INSTRUCTIONS TO PERFORM CAMPAIGN 131

Certain 2015 Winnebago® Vista models WFE26HE/WFE31KE and Itasca® Sunstar models IFE26HE/IFE31KE motorhomes.

Figure (A) indicates diverter above cooktop that will be replaced with damper plate

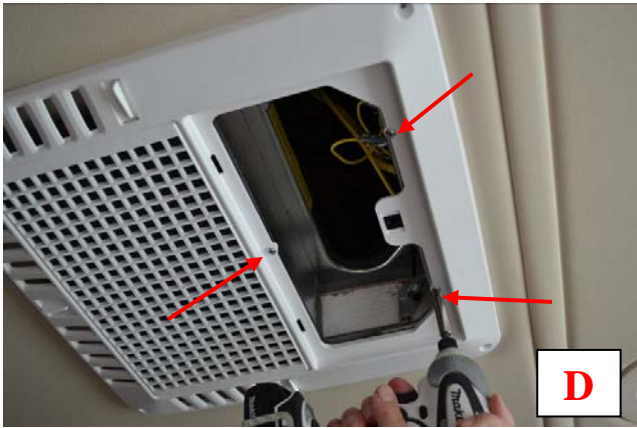
1. Remove (4) screws from perimeter of inside roof A/C assembly, (set aside). See figure A and B.

5. Using caution not to damage retaining tabs, install damper plate in place of diverter (label side up). See *figure G*.
